UNITED STATES PATENT AND TRADEMARK OFFICE

APPLICATION NO.	FILING DATE	FIRST NAMED INVENTOR	ATTORNEY DOCKET NO.	CONFIRMATION NO.
10/630,443	07/30/2003	Jerry E. Bandstra	2-5169-049	9315

Office Action Summary

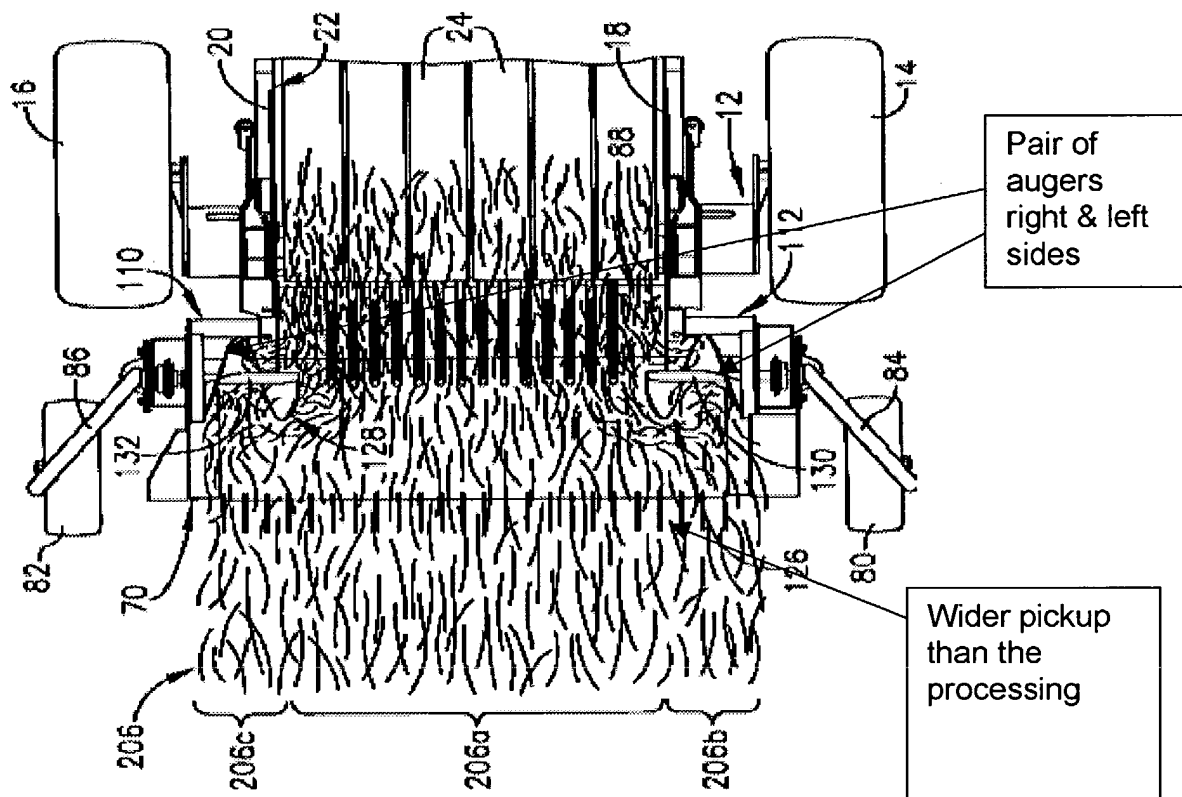
6. Claims 1-17 are rejected under 35 U.S.C. 102(b) as being anticipated by Ratzlaff et al (6029434).

In re claim 8. An apparatus for crop processing having a processing width defined by a distance between a left side and a right side of a processing unit, the apparatus comprising:

(a) a pickup header that is wider than said processing width; and

(b) a pair of augers on at least one of a right side and a left side of the pickup header to move crop material laterally.

Laid back tooth

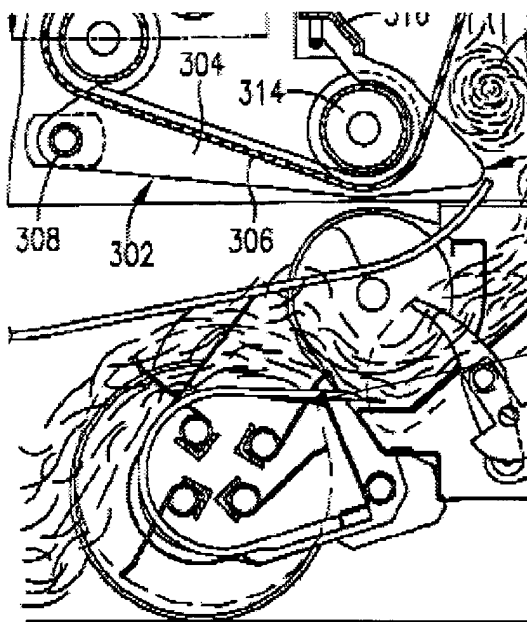
In re claim 9: additionally comprising teeth in the pickup header, said teeth comprising a laid back tooth having an angle measured between itself and a radial line passing through the pickup header axis and a base of the laid back tooth greater than teeth having other characteristics in the pickup header.

Sweeps under

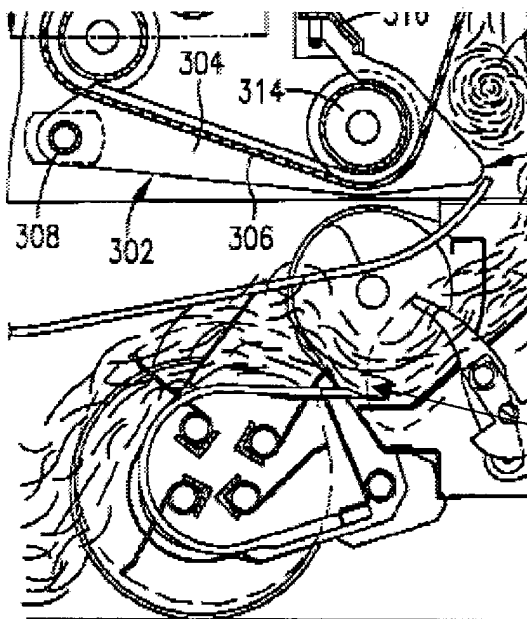
In re claim 10: wherein the laid back teeth are used in a region of the pickup header that sweeps under the at least one pair of augers.
